Service Bulletin

SB 81438-XX-00-15

Rev. C

Release of operating system -242M.

Figure 4
Back View of Rear Panel
Service Bulletin Label and Identification Label

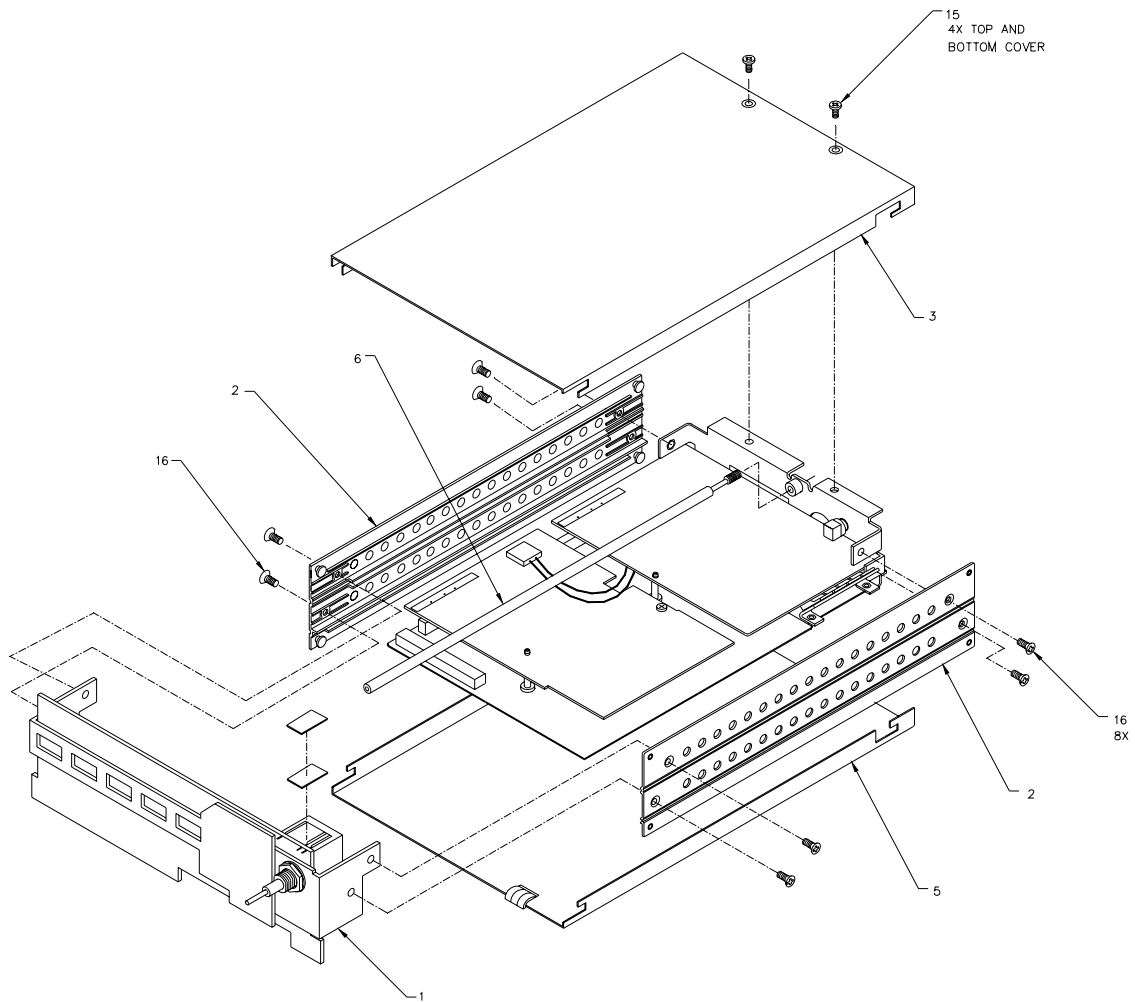
When the Checkout has been performed and the unit has passed satisfactorily, refer to Figure 4 and replace the old Identification Label with the supplied Identification Label (Figure 4, Item 9) on the rear panel.

Figure 1
Disassembly of 2000 Approach Chassis

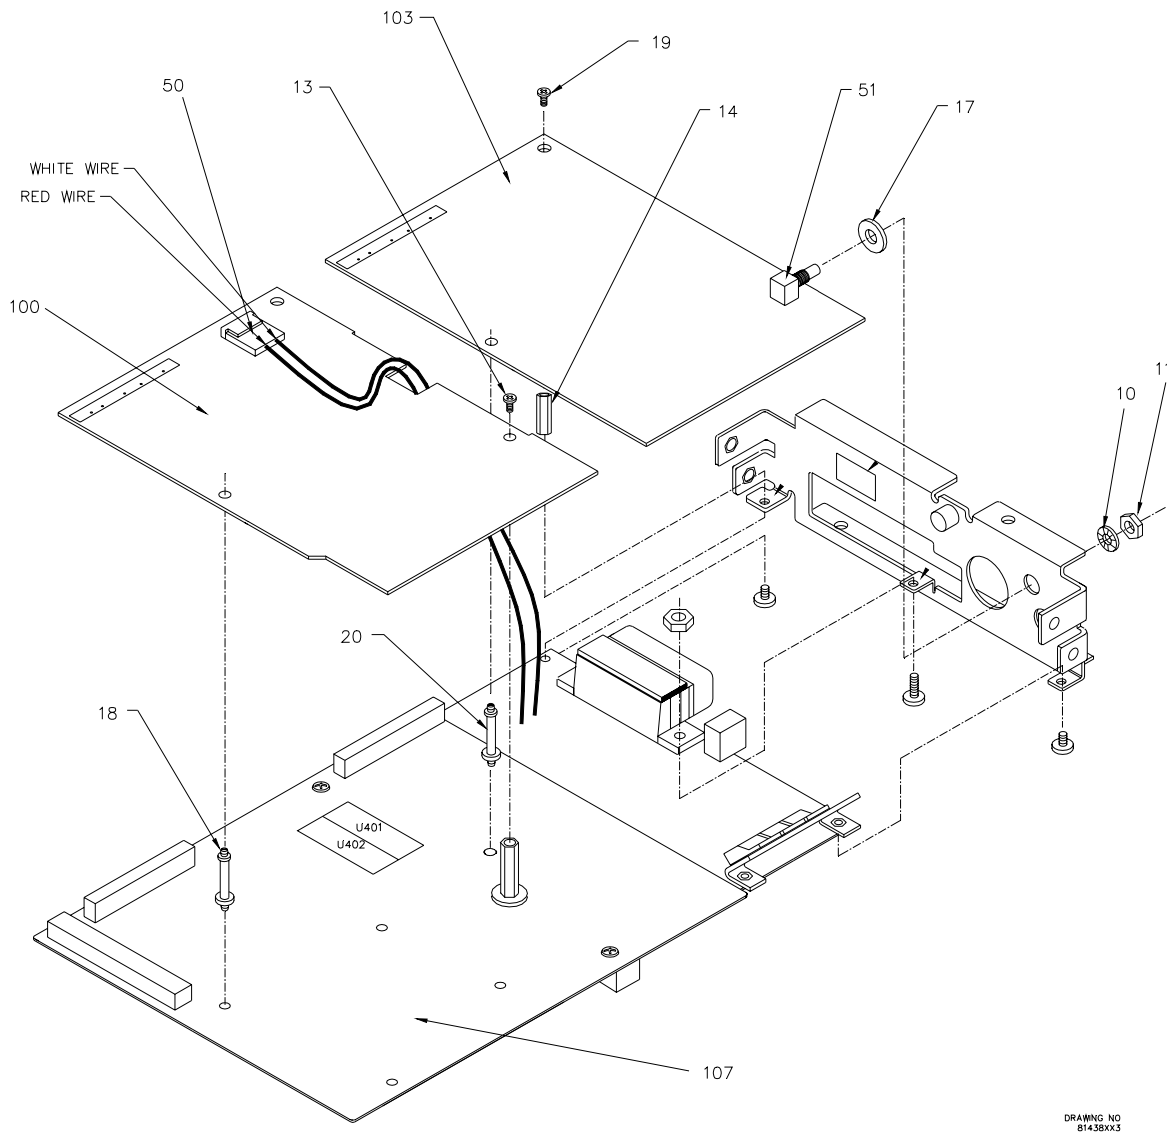
1. Place the unit on an anti-static mat.
2. Remove the NavData card if in the unit and place the card in an anti-static bag.
Refer to Figure 1.
3. Remove 2 screws (Item 15) from top.
4. Slide the top cover (Item 3) towards the rear and lift off cover.
5. Unscrew mounting shaft (Item 6) and carefully remove from unit taking care not to bring shaft into contact with components inside unit.
6. Remove 2 screws (Item 15) from bottom (Item 5). Slide bottom towards rear of unit and lift off.
7. Remove 8 screws (Item 16), 4 from each side. Remove side rails (Item 2).
8. Remove Display Assembly (Item 1) by pulling straight forward.
Refer to Figure 2.
9. To reduce the possibility of electric shock, discharge capacitors C9-C11.
10. Disconnect wires (Item 50) from connector P4 on Power Interrupt CCA (Item 100).

3. Install the side rails (Item 2). Attach screws (Item 16) to side rails at the rear (2 places).
4. Install the Display Assembly (Item 1), carefully inserting pins into connector.
5. Attach screws (Item 16) to side rails and Display Assembly at front (2 places).
6. Install the bottom cover (Item 5) by sliding forward.
7. Attach 2 screws (Item 15) at rear of bottom cover.

1. Install the mounting shaft (Item 6), taking care not to bring it into contact with components inside the unit.
2. Install the top cover (Item 3) by sliding the front lip under the edge of the Display Assembly (Item 1).
3. Attach 2 screws (Item 15) at rear of top cover.

Figure 2
Disassembly of CCAs

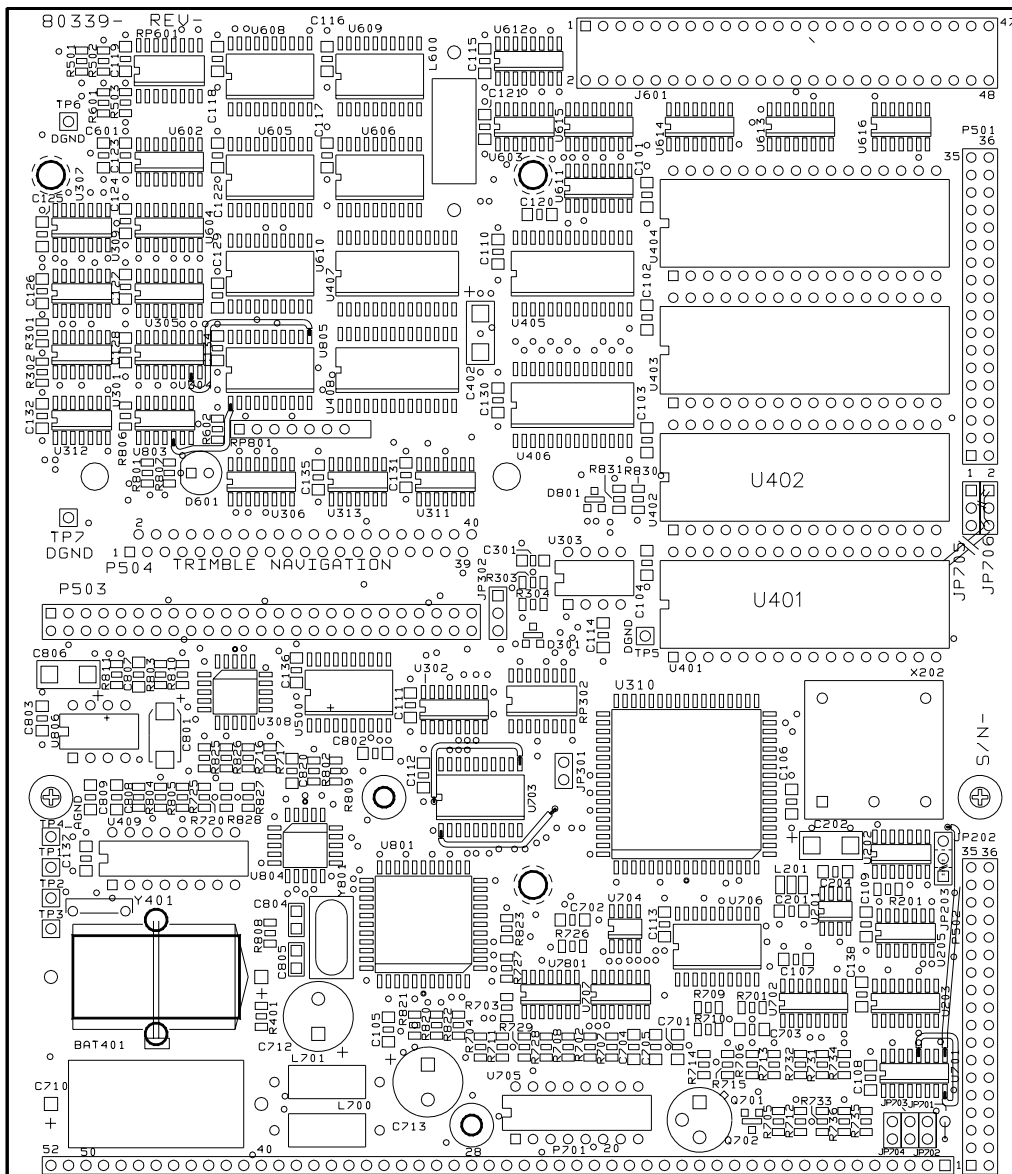
1. Connect red and white wires (Item 50) to P4 on Power Interrupt CCA (Item 100). (Verify that wires are oriented correctly.)
2. Replace screw (Item 13) on Power Interrupt CCA (Item 100).
